PZ&B Staff Combination Memorandum: Town Council and Landmarks Preservation Commission

SUBJECT: HSB-23-009 (ZON-23-111) 269 PARK AVE (COMBO)

MEETING: DECEMBER 20, 2023 LPC
JANUARY 10, 2024 TC

Revised Second Submittal Proposal

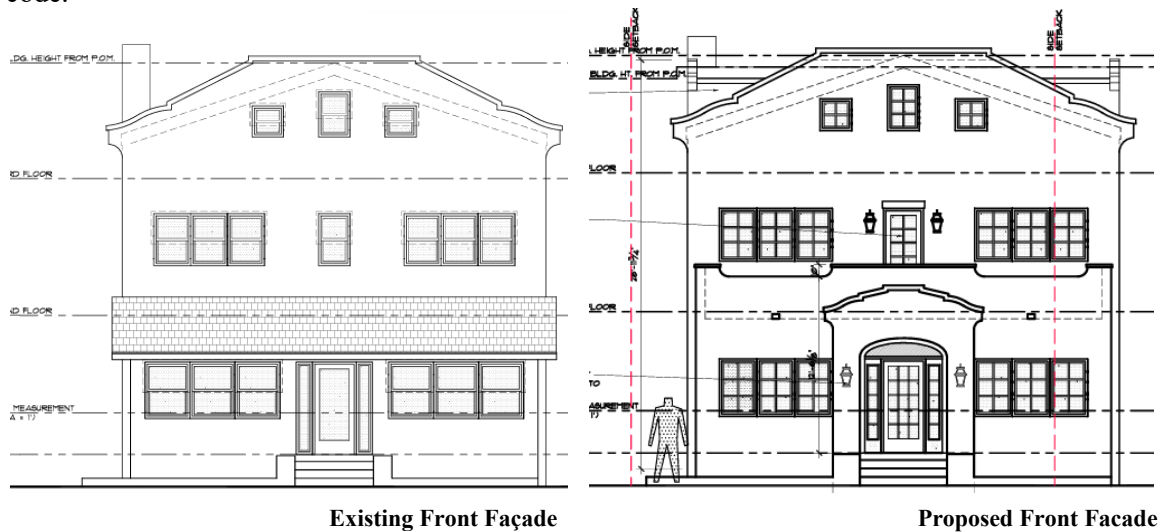
that through the design review process, the applicant modified the proposal as originally presented to staff and moved the two front dormers further back from the street between First and Second Submittals as depicted below:

The Town's historic preservation consultants maintain that the installation of four new dormers, with two being located towards the front of the building, is not appropriate and is unnecessary for the proposed storage space use. One larger dormer, centrally located on the east and west facades, would provide natural light, egress if needed, and greatly minimize the visibility from the street.

Alternatively, staff is amenable to exploring a further step back behind the existing chimney, as depicted above, for the two southernmost front dormers. Otherwise, with the elimination of two of the four dormers, staff is supportive of Variances 2 and 3.

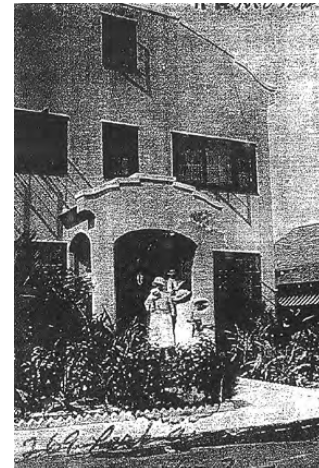
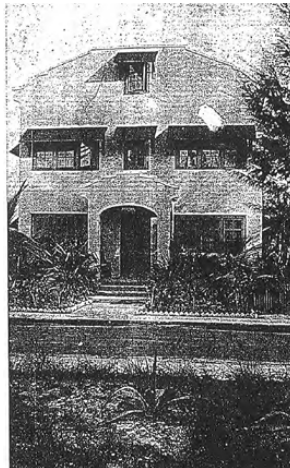
The architectural improvements to the primary façade include the construction of a gabled covered entry which is closer to the street than currently permitted and will further exacerbate the existing non-conforming front setback by bringing a portion of the front entry 1'-0" closer. Staff is highly supportive of the chosen design, which incorporates a feature that is evocative of the original entry. The 1927 permit and drawings that are presented as evidence of the front addition are likely of the rear addition, as the floor plan shows the entry door in an off-center location and notes that it contains kitchen features such as a stove, sink, and icebox. There is not a building
